# Accessibility Survey

## City of Downey Dalen Street - Barlin Avenue To Lakewood Boulevard

Date of Inspection  
4/5/2017

**Disability Access Consultants**

**Change In Level West Of Lakewood Boulevard @ 33.916580702814, - 118.141236752272**

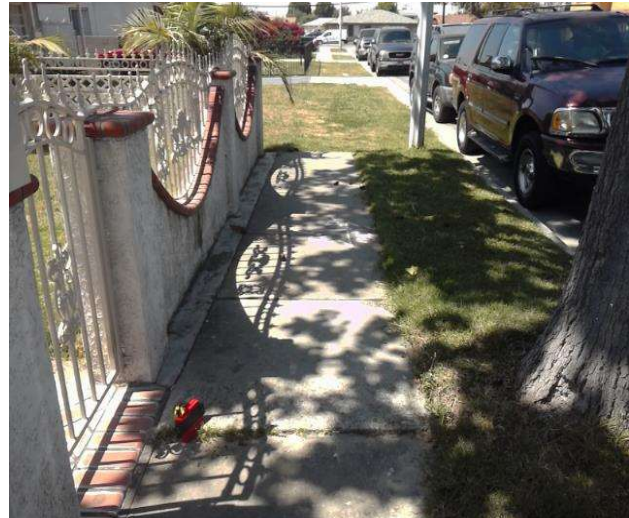
There is a change in elevation greater than recommended value.

**On-Site Finding** 0.75 inches

Ensure that the change in elevation is within the recommended value.

Recommendation Up to 0.25 inches

**Sidewalk East Of Barlin Avenue @ 33.916978013153, -118.141698092222**

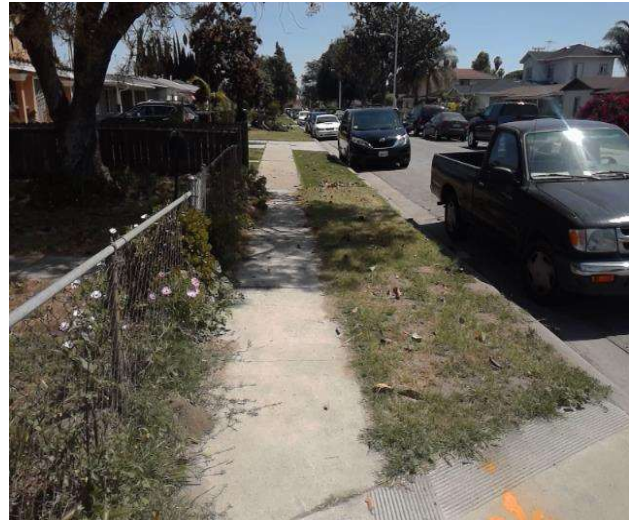
Sidewalk cross slope is not compliant.

**On-Site Finding** 3.30 percent for 31.00 feet

Repave the sidewalk surface with the recommended cross slope.

Recommendation Up to 2.08 percent
